Resource consent application at 1110 Great South Road, Mount Wellington (LUC60344578) - Section 92 request

Date	2 October 2019
From	Jon Styles
To	Jodie Mitchell
Project	Ōtāhuhu / Mt Richmond - Exotic Tree Removal
Re	LUC60344578 Request for further information

Subject: Otahuhu/MT Richmond vegetation Removal

Aerial highlighting the London Plane in the south eastern corner of the Rovers Rugby Clubrooms buildings.

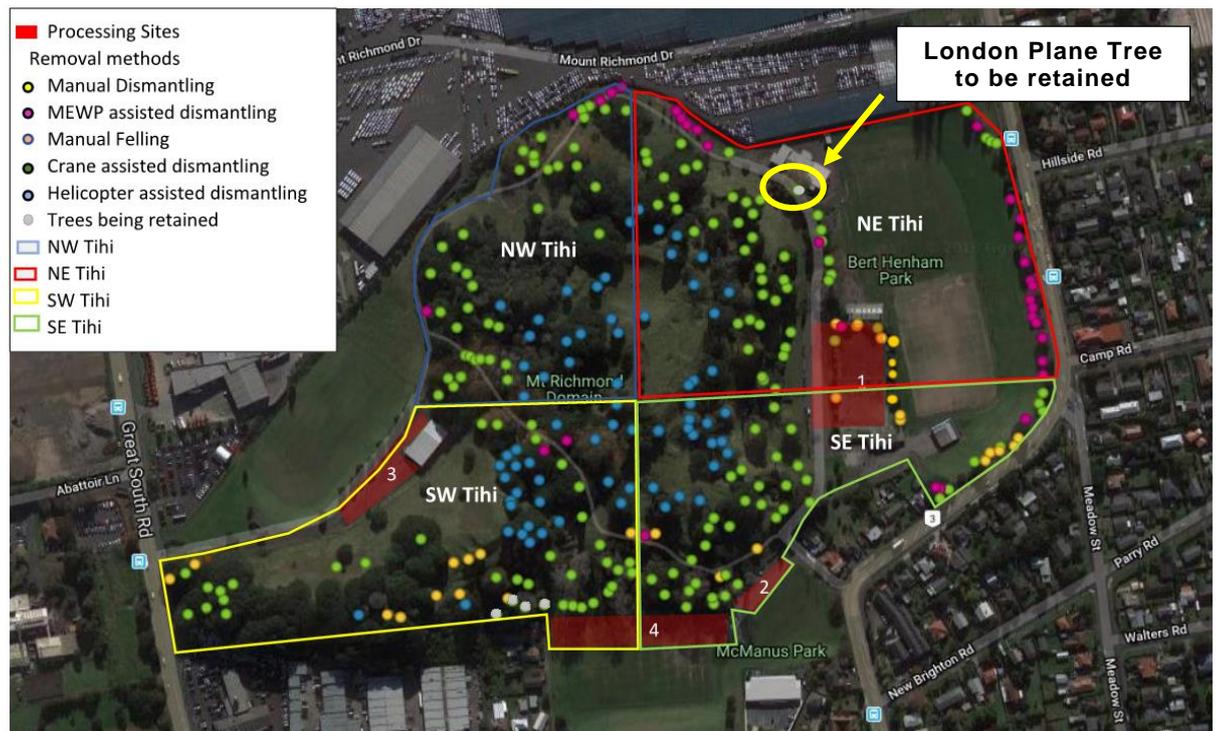
Retention of the London Plane tree

5. The location of the tree is shown on Figure 3 of the Tree Removal Methodology prepared by Treescape² and highlighted on the aerial below.

You will recall from past discussions that the assessment of visual effects identified potential adverse effects arising from the total removal of exotic trees around the sports buildings in Bert Henham Park, particularly when viewed from Mt Wellington Highway. The London Plane tree is question is considered to have a scale and location that contributes to the integration of the adjacent building into the landscape and for that reason is proposed to be retained.
